BULLETIN ACD98-156

SUBJECT: DURASTOP TECHNICAL BULLETIN
RE: PRMATURE WEAR AND/OR OVERHEATING
FRONT BRAKES .

Vehicles Involved: 1988 through early model 1990 Pontiac LeMans equipped with solid front disc brake rotors and 1.6L engines.

fig. 1

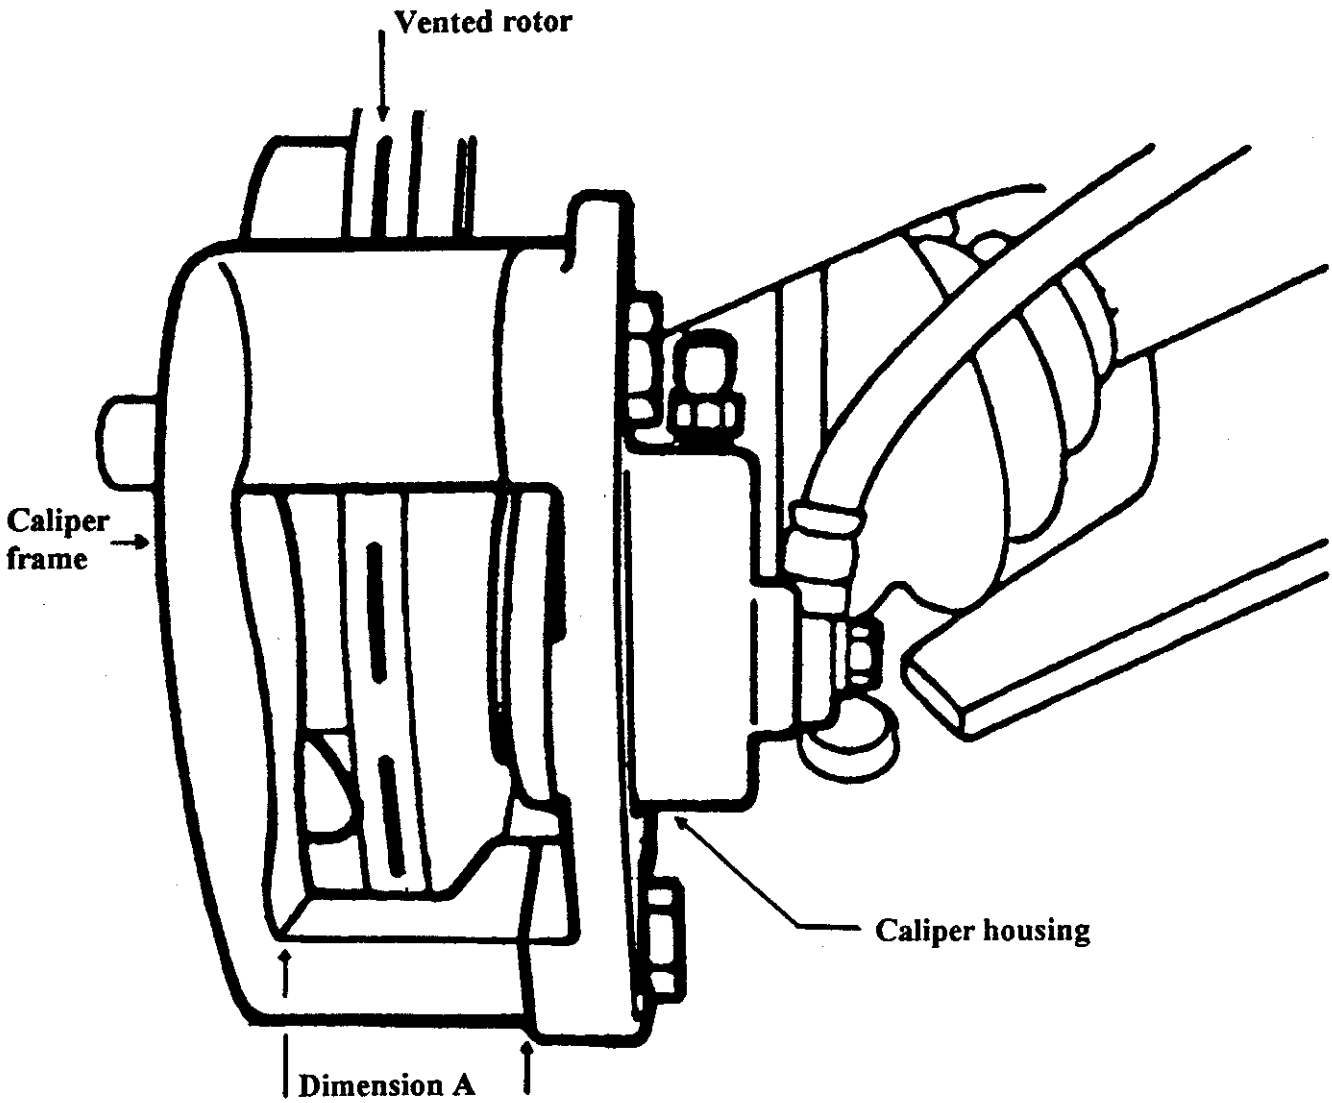
Note: The LeMans use calipers that consist of two main parts, the piston housing and the caliper frame (fig. 1). These must be used as a matched set to allow for the thicker vented rotor. Do not reuse the early design caliper frame.

Note: Late design caliper frame is larger to allow for vented rotor (dimension A).
